N9923A-05A

Modification Recommended Service Note

N9923A – 4/6 GHz FieldFox RF analyzer

Affects: N9912A and N9923A

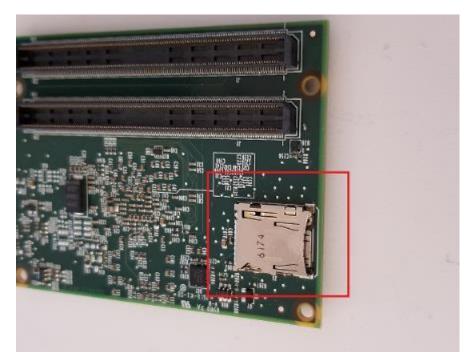
c. Using an Exacto Knife remove the Epoxy bridge holding the SD Card into the SD card socket.

d. Use caution to not damage the socket or other parts of the CPU board.

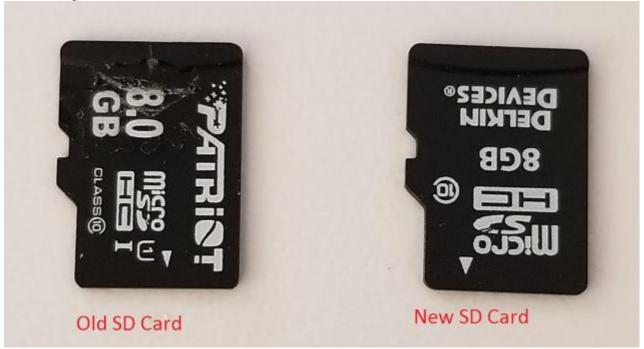
e. To remove the SD card, press the SD card slightly in towards the socket, it will click and then release to remove the SD card. Remove any extra epoxy that may be left.

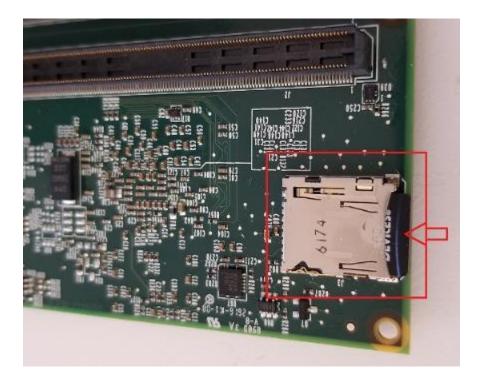
f. Here are the Old and New SD cards. The old SD card (Patriot) is on the left. The New (Delkin) is on the right.

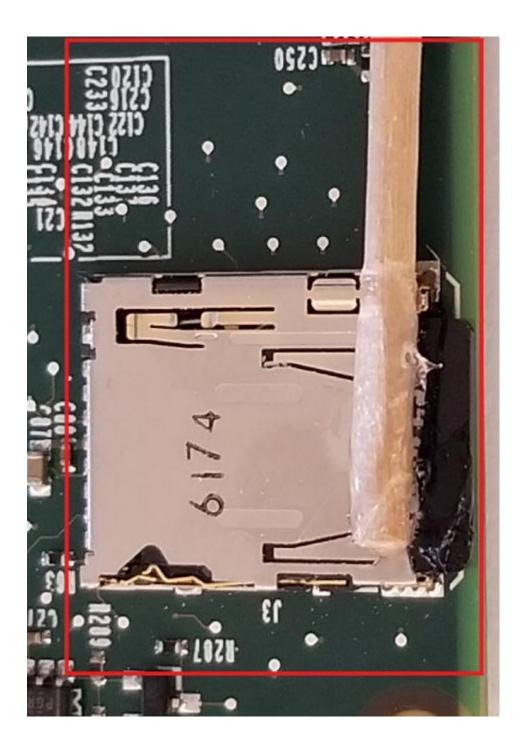
g. Insert the NEW SD card into the SD card socket and press it in until you hear a click, then release. The SD card is now locked in the socket.

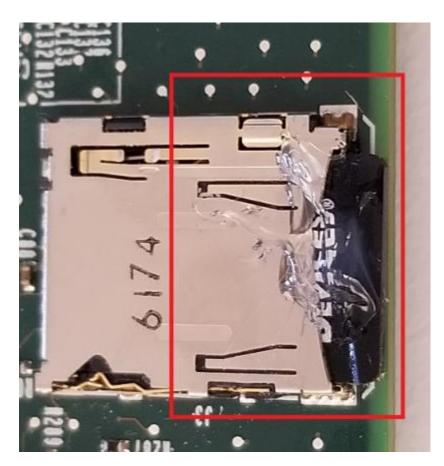
h. It is now necessary to add a small amount of RTV (part number 0470-0450) to bridge the SD card to the SD card socket. Using a wooden Q-Tip place a small amount of RTV on both the SD card and the socket.
